MCQV* / MCQI* / MCBQV* / MCBQI* / MCQVS / MCQV2L

Change Notification

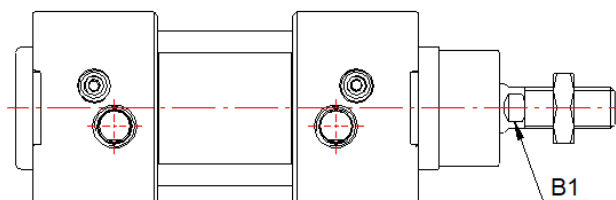
Conform to ISO 15552.

Dimension B1

Before		After																					
<table><tr><th>Code Tube I. D</th><th>B1</th></tr><tr><td>50</td><td>16</td></tr><tr><td>63</td><td>16</td></tr><tr><td>80</td><td>21</td></tr><tr><td>100</td><td>21</td></tr></table>	Code Tube I. D	B1	50	16	63	16	80	21	100	21		<table><tr><th>Code Tube I. D</th><th>B1</th></tr><tr><td>50</td><td>17</td></tr><tr><td>63</td><td>17</td></tr><tr><td>80</td><td>22</td></tr><tr><td>100</td><td>22</td></tr></table>	Code Tube I. D	B1	50	17	63	17	80	22	100	22	
Code Tube I. D	B1																						
50	16																						
63	16																						
80	21																						
100	21																						
Code Tube I. D	B1																						
50	17																						
63	17																						
80	22																						
100	22
